LAKESHORE PARK BUILDING JSP17-43

Consideration at the request of NSA Architects, Engineering, Planners for approval of Preliminary Site Plan and Stormwater Management Plan. The subject property is located in Section 3 west of Old Novi Road and south of South Lake Drive and is zoned R-4, One Family Residential. The applicant is proposing an update to Lakeshore Park in the City of Novi including an approximately 9,400 square foot community center, 129 parking spaces, one pavilion, and a bike lane to connect to the mountain biking trails.

MOTION SHEET

Checked: JB Approved: RB

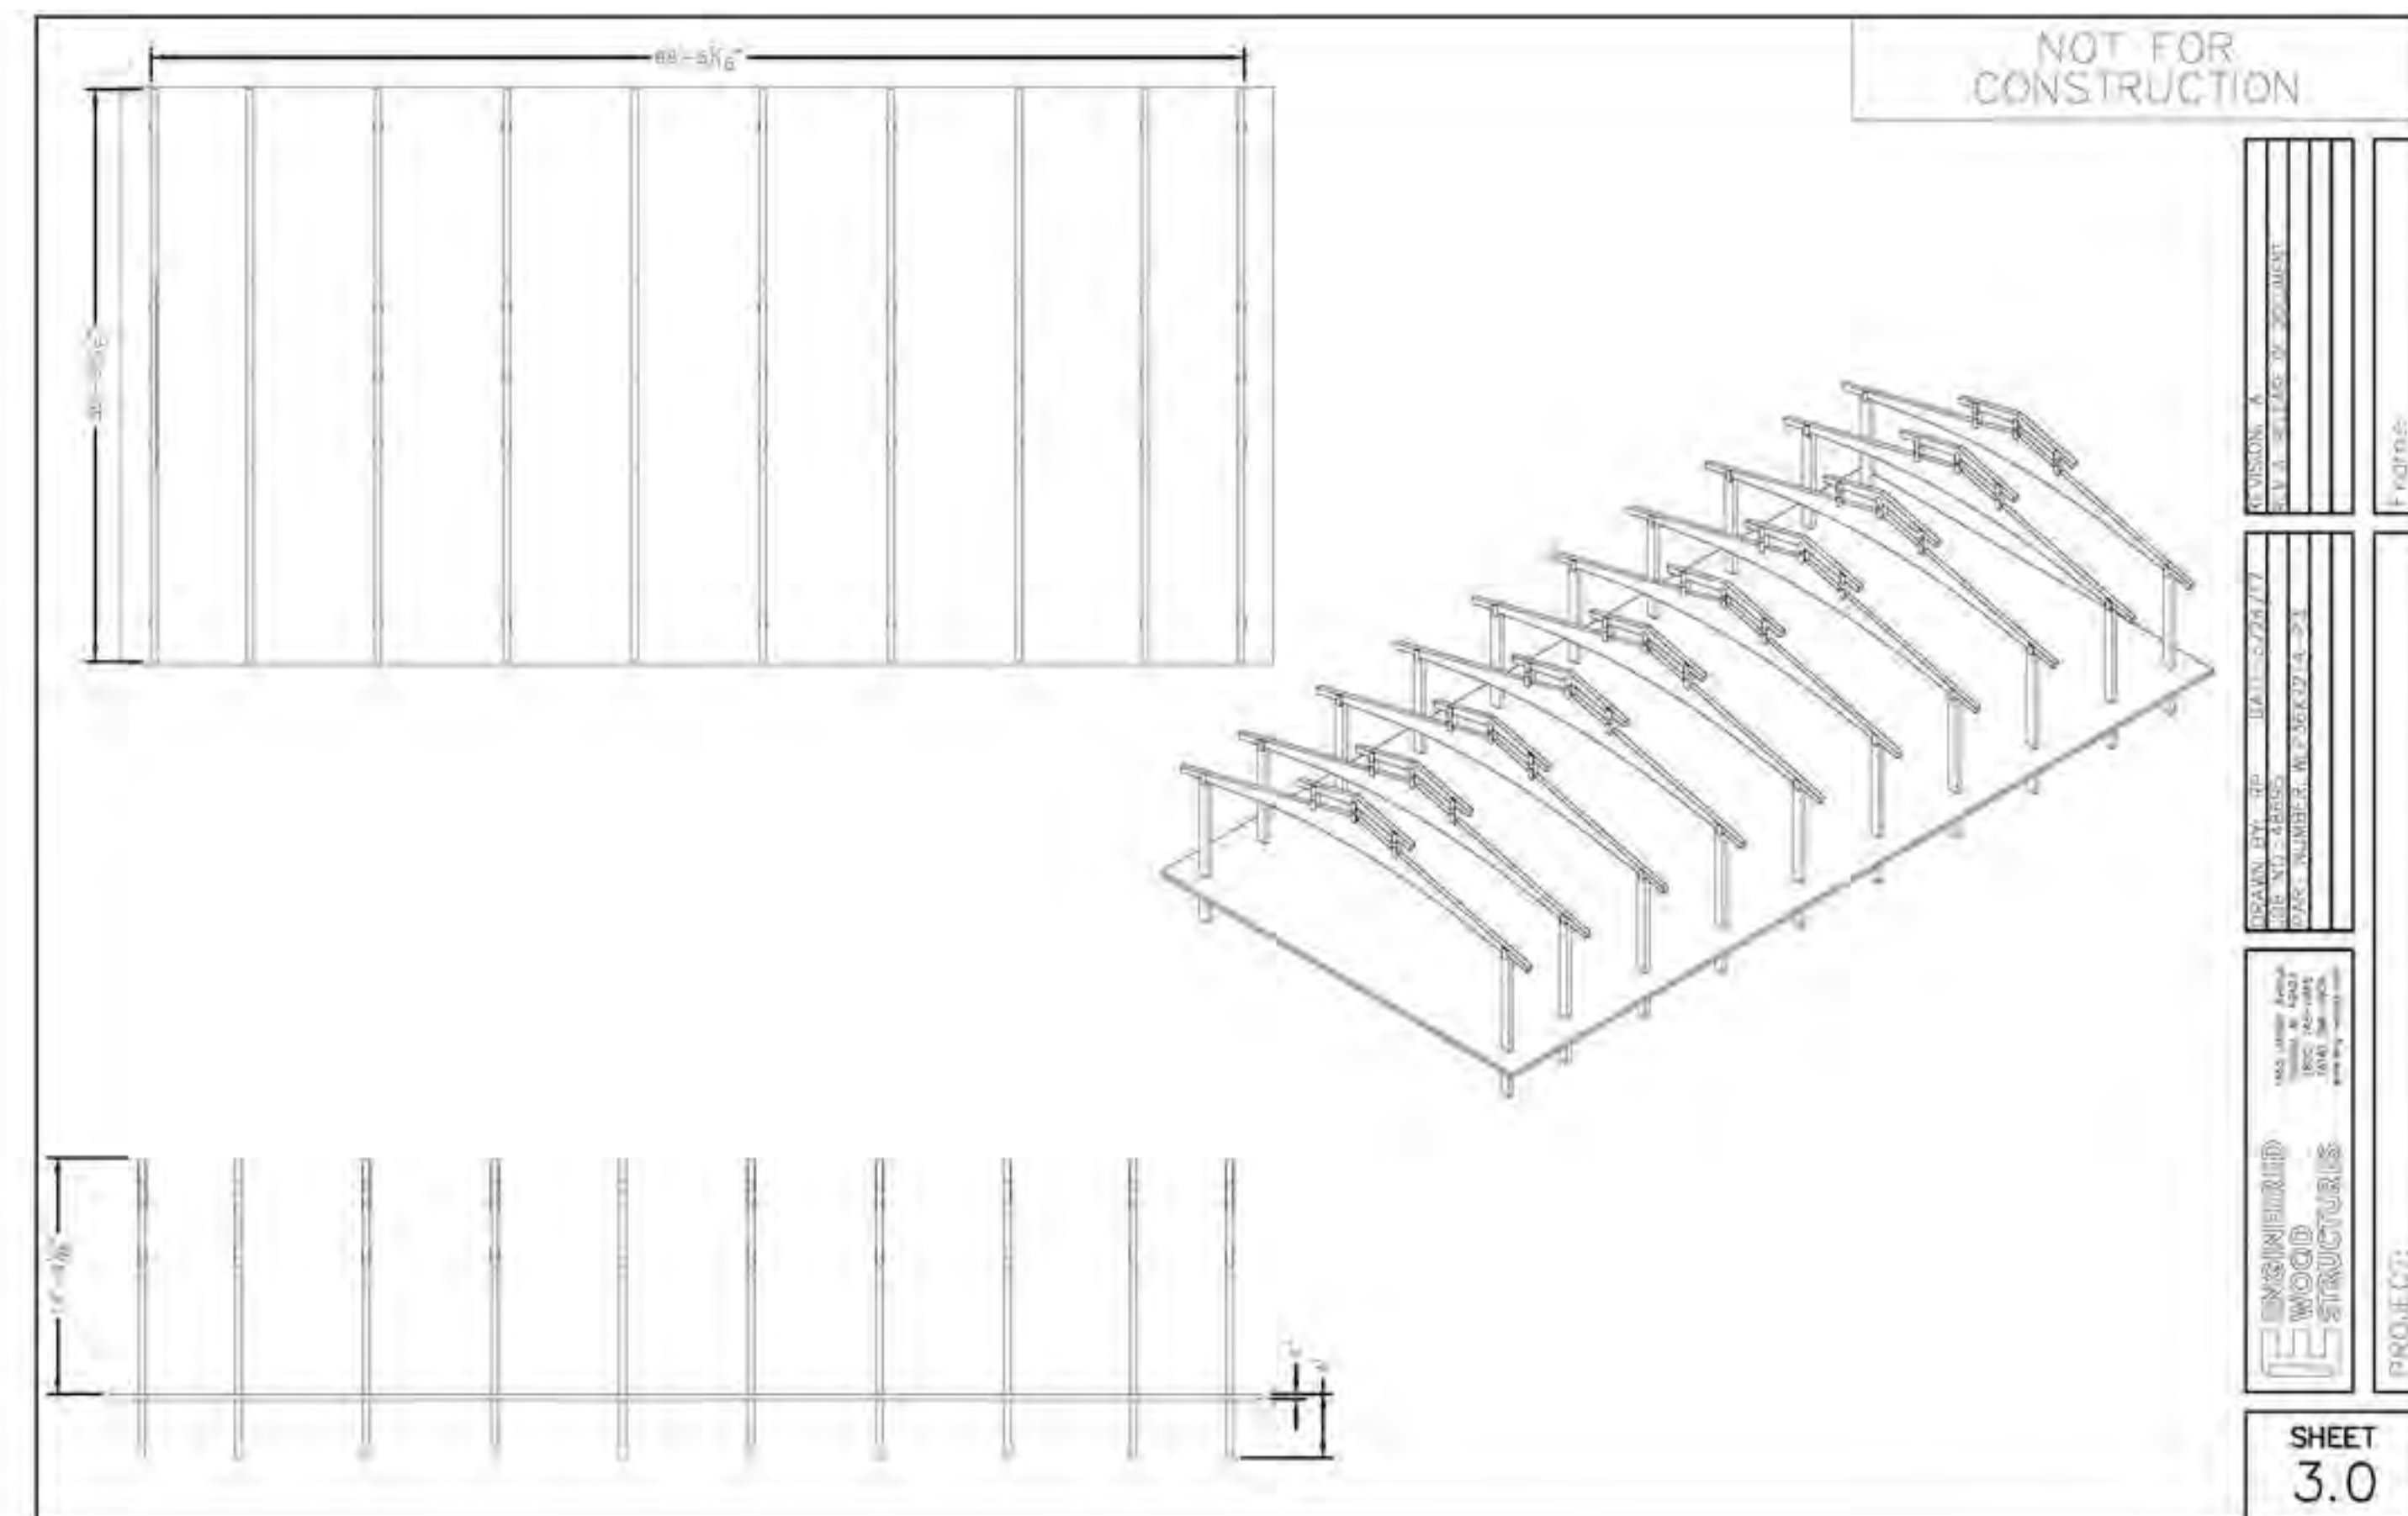
Response: A Section 9 Waiver was requested. A note requesting the waiver can be found on Sheet A-201.

Response: All mechanical equipment is contained within a fully enclosed roof well, surrounded on all sides by a minimum of 6 feet of vertical walls and buried within the center of the metal roof. This is indicated on both the Exterior Elevations (sheet A-201) and the Roof Plan (sheet A-121)

DRAWING NUMBER:
C-3.0

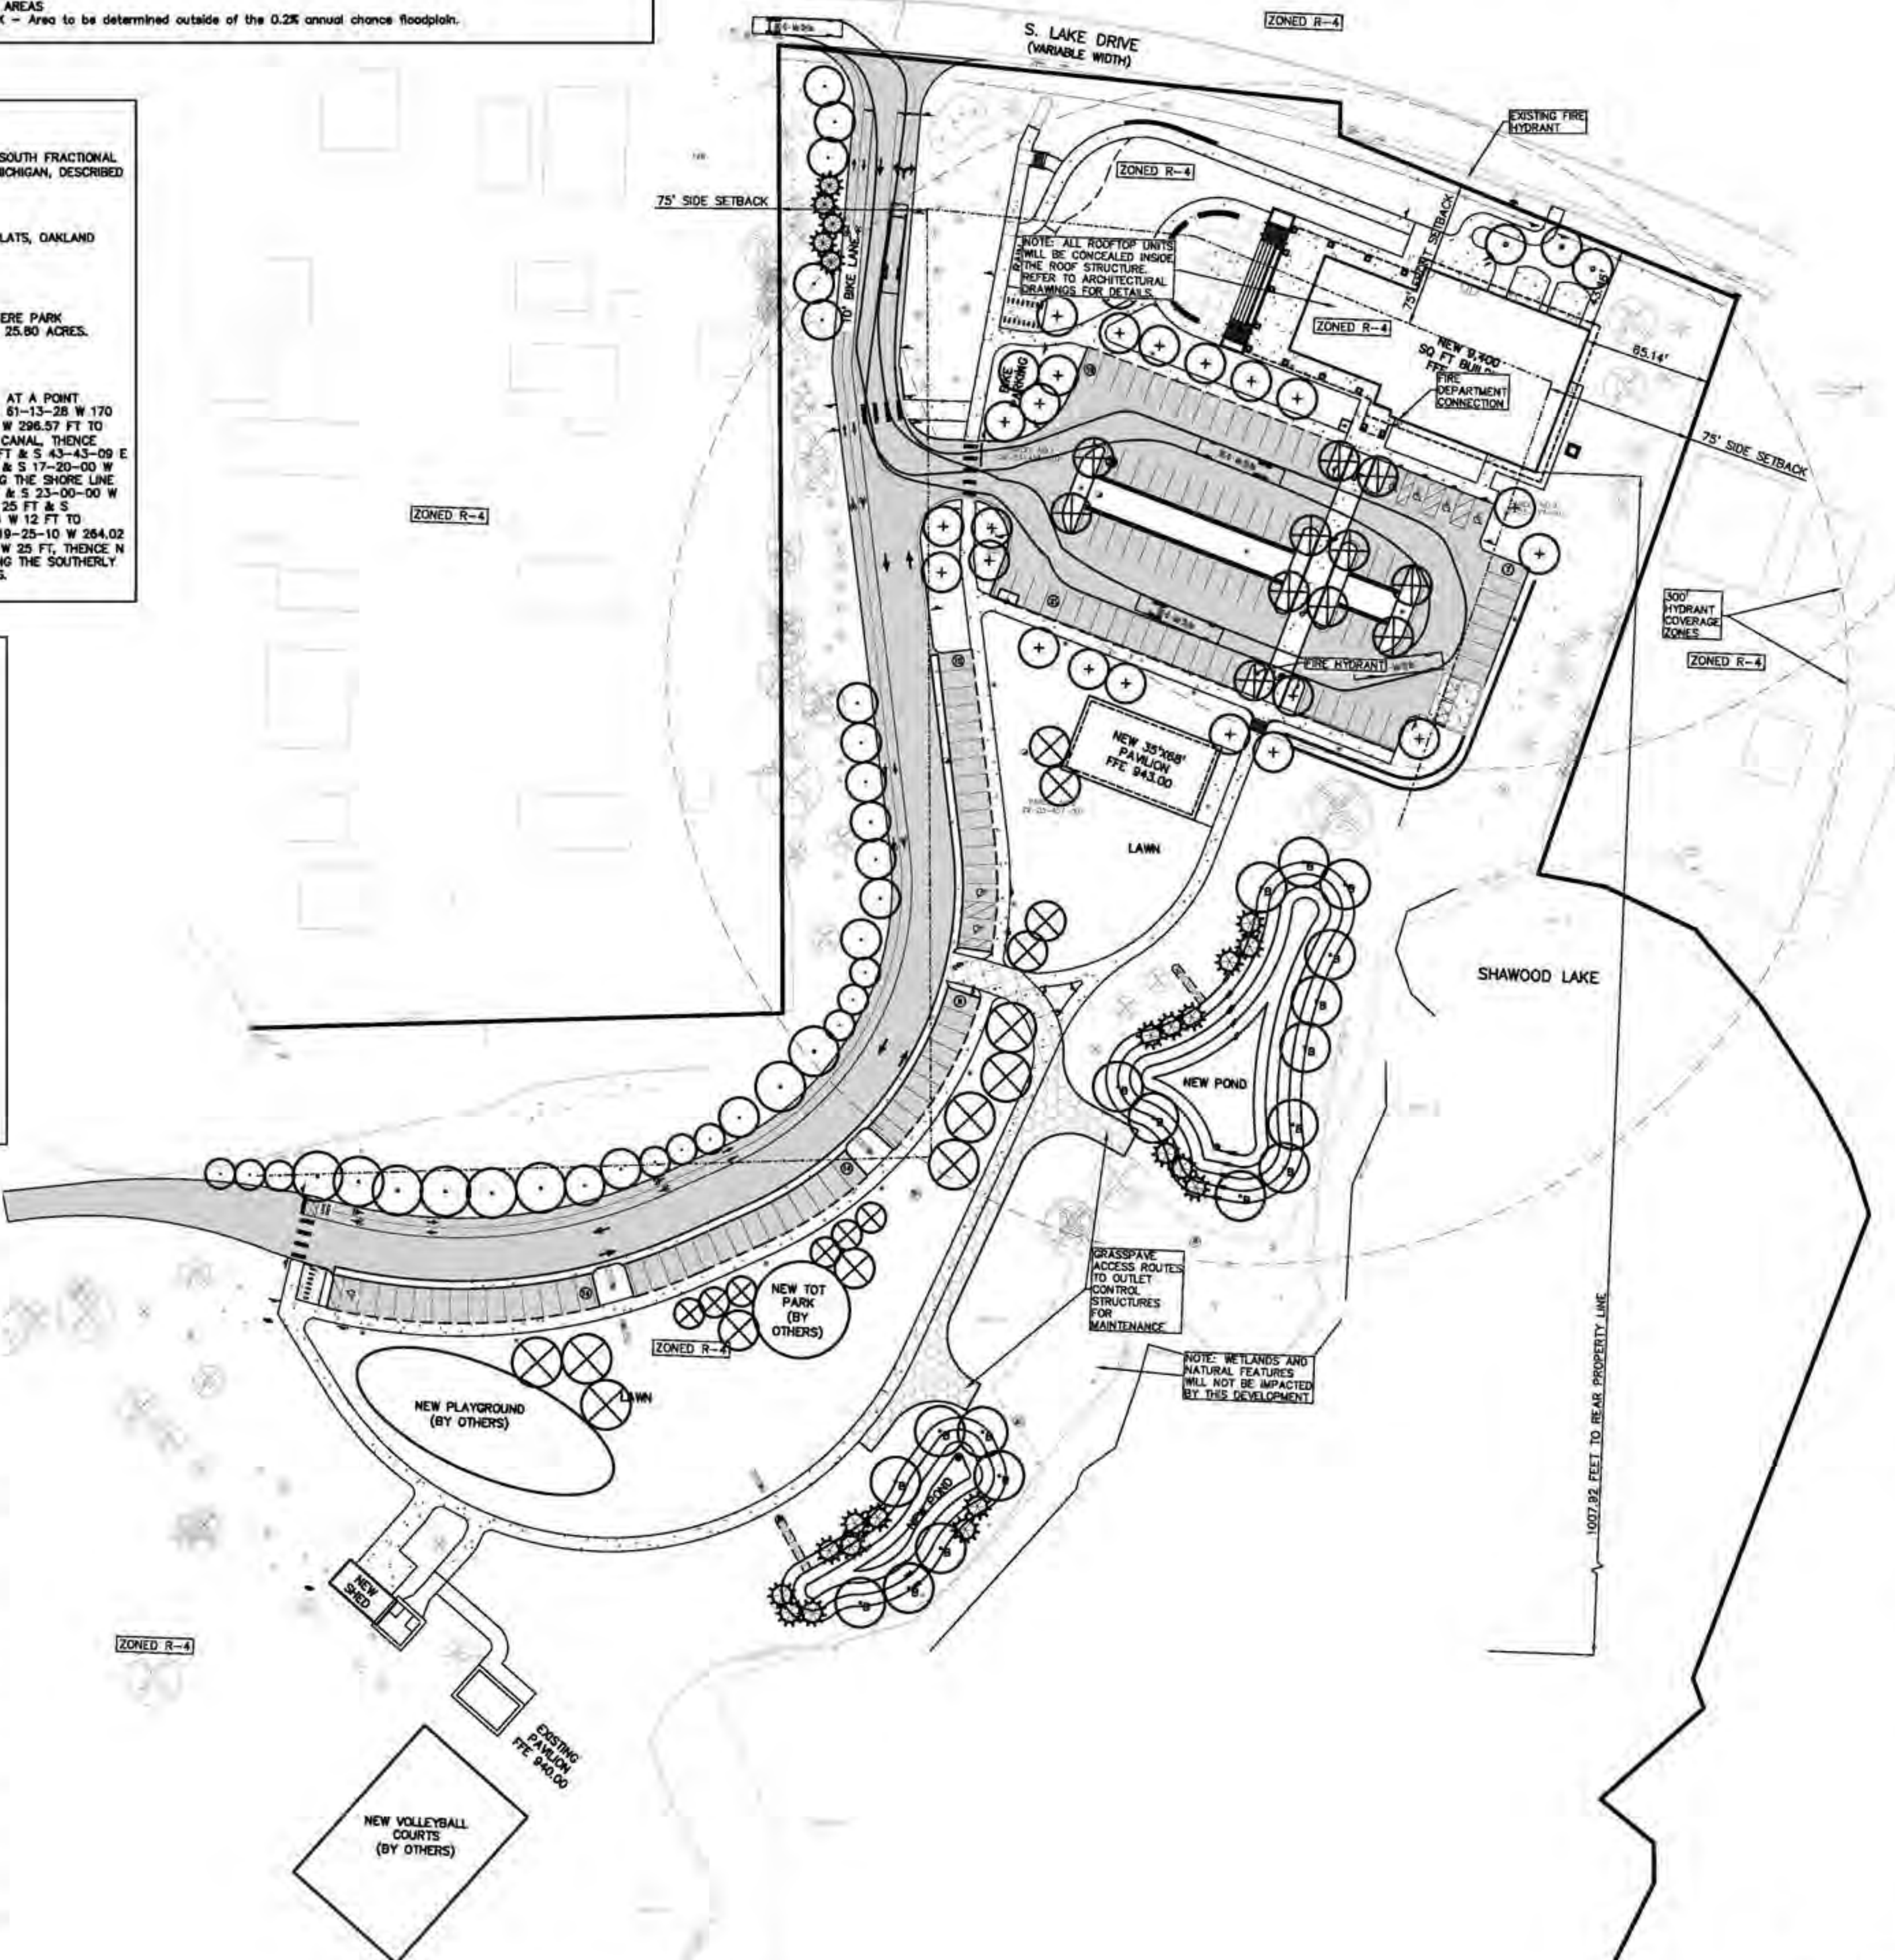
Response: The front setback will be shown and labeled on sheet C-3.0.

Response: The building will be shifted westward to comply with the 75' required setback. This will be shown and labeled on sheet C-3.0.

DRAWING NUMBER: **C-3.1**

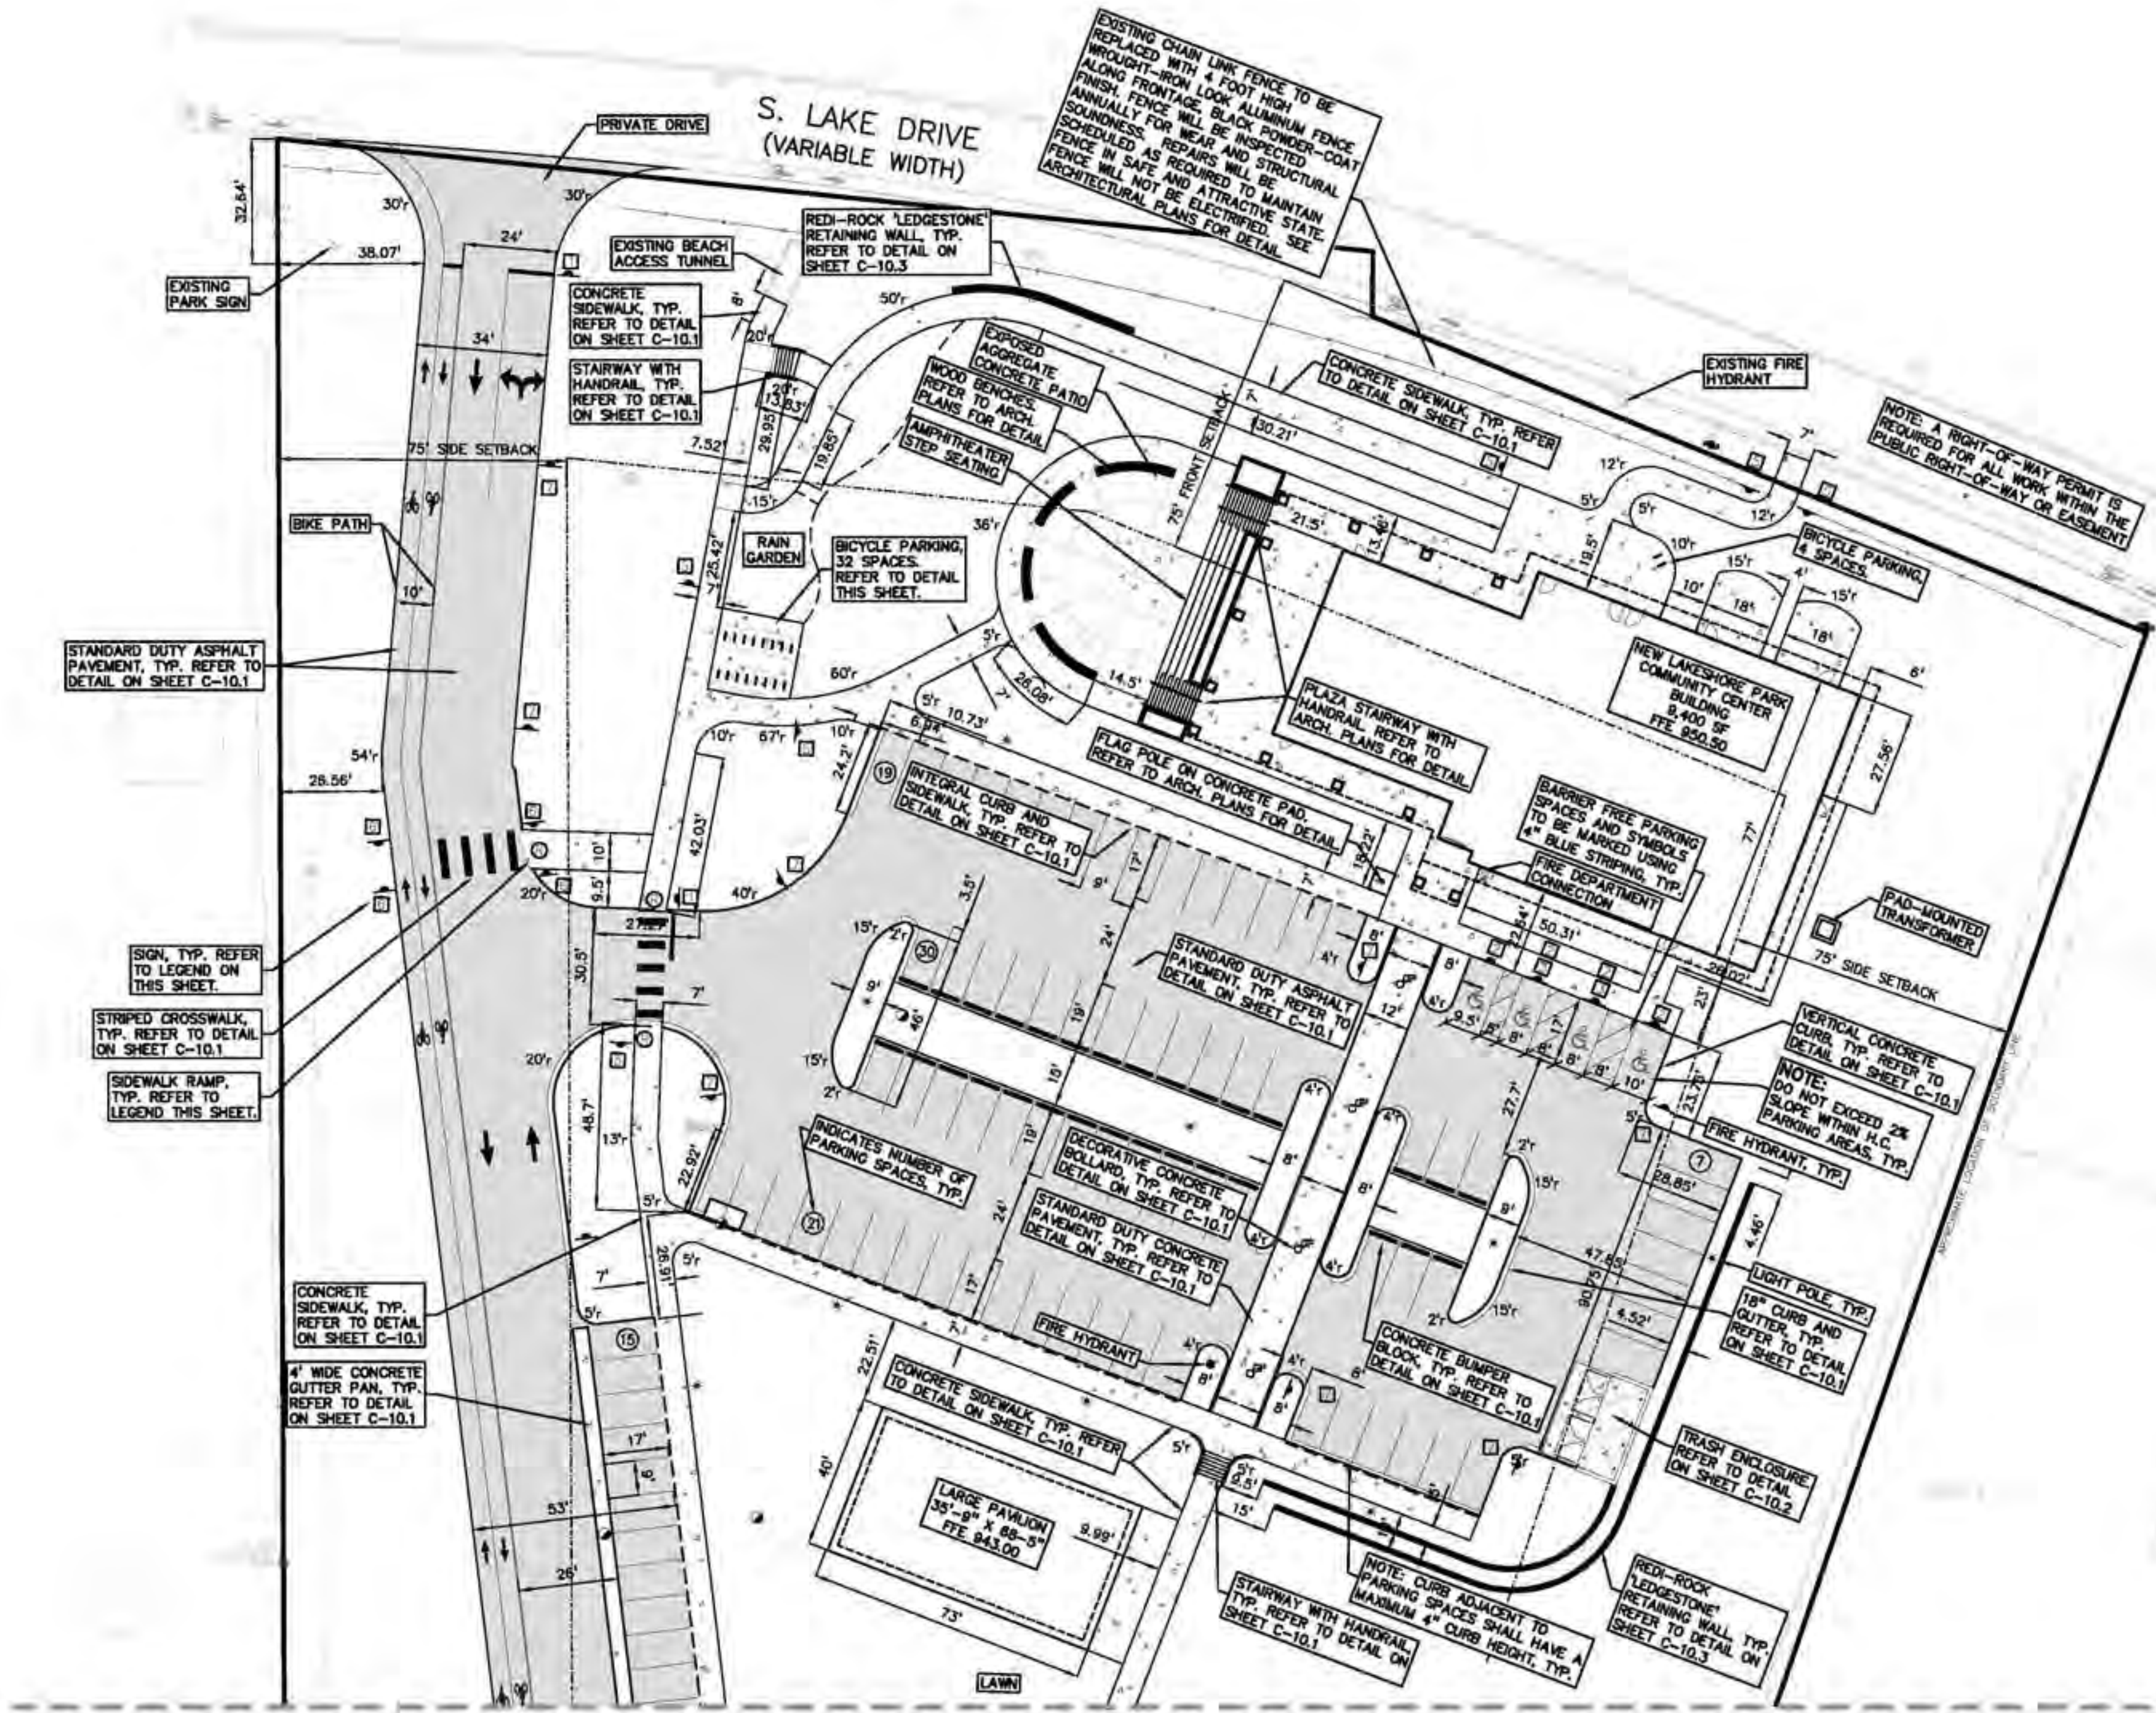
Response: Parking will be revised as required to comply with 5.4.2.A of the Zoning Ordinance. Changes will be shown on sheet C-3.1.

Response: Parking island widths will be updated to be 10' feet in width on sheet C-3.1

Response: Stop sign size will be updated in the table on sheet C-3.1.

Response: Fire lane signage will be revised on sheet C-3.1.
